SUPPLEMENTAL INSTRUCTION

PROJ.: **Boys and Girls Club Prince of Wales**
PROJ. No.: **1716**
DATE: **Apr 2, 2018**
S.I. No. **S.I. - 022**

Revision of Rain Water Leader from 3" to 4" – Multipurpose room

Mechanical Contemplated Change Notice (MCCN)

DRAWING NO.
MSK-1

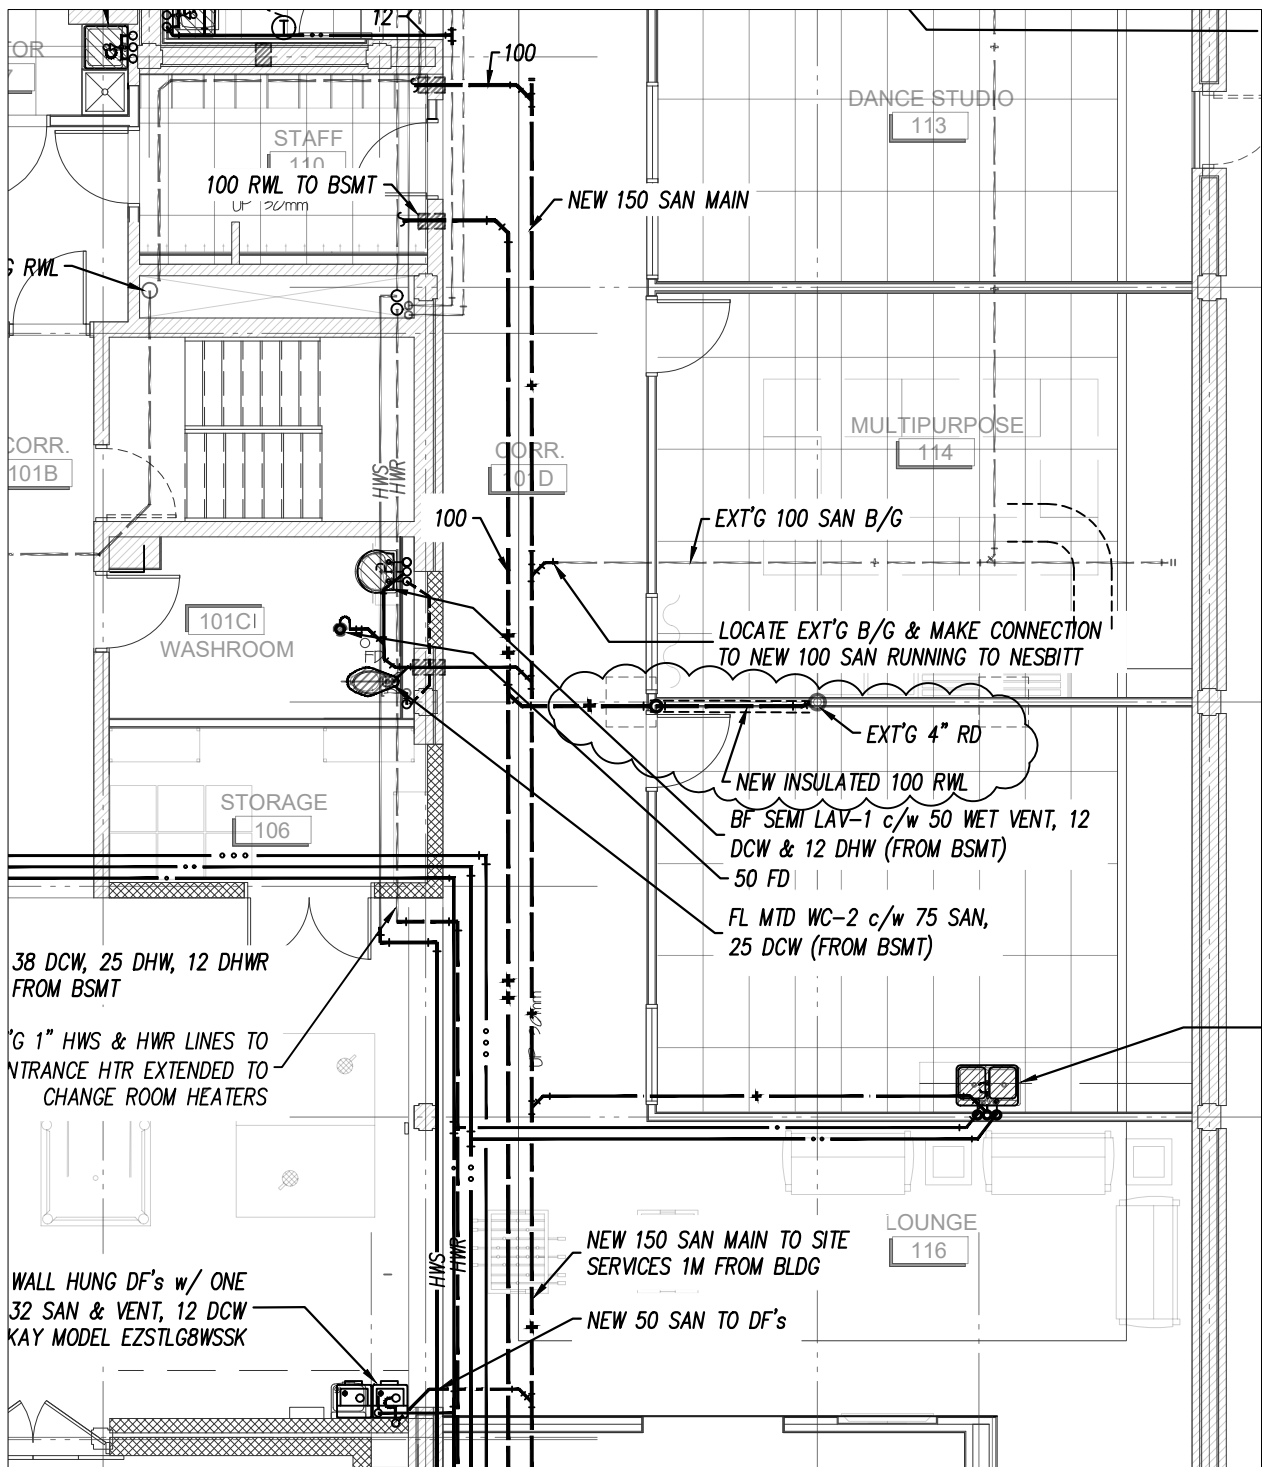
1. See MSK-1
 - a. Revise New Rain Water Leader with insulation from 75mm (3") to 100mm (4") from existing 4" Roof Drain to new storm below slab.
